<b>DTC (Code)</b> P0402 - 00 <b>Codigo:</b>	<b>Bulletin:</b> RD18-002 <b>Date Fecha:</b> August 12, 2018
<b>Description:</b> Engine Exhaust Gas Recirculation Differential Pressure - Mechanical system not responding properly	
<b>Application:</b> US13 - US20 Emissions

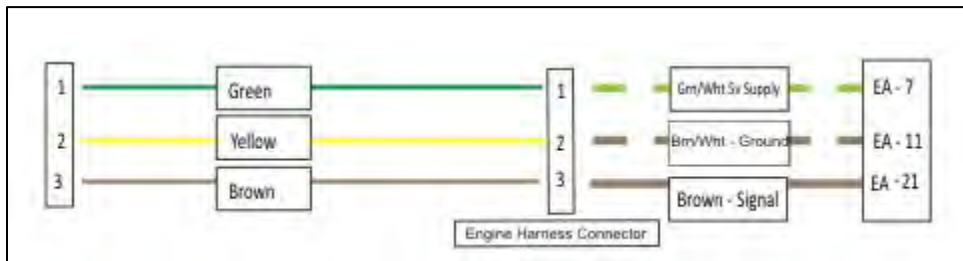
*Note: When installing the kit for the updated EGR differential pressure sensor for the D13 engine, the engine harness connector pins will need to be relocated. The previous pin locations were:*

- Pin 1 — Green/White
- Pin 2 — Brown
- Pin 4 — White/Brown

*Note: The new engine harness connector pin locations when replacing old style EGR differential pressure sensor with the new style sensor in kit are:*

- Pin 1 — Green/White
- Pin 2 — Brown/White
- Pin 3 — Brown
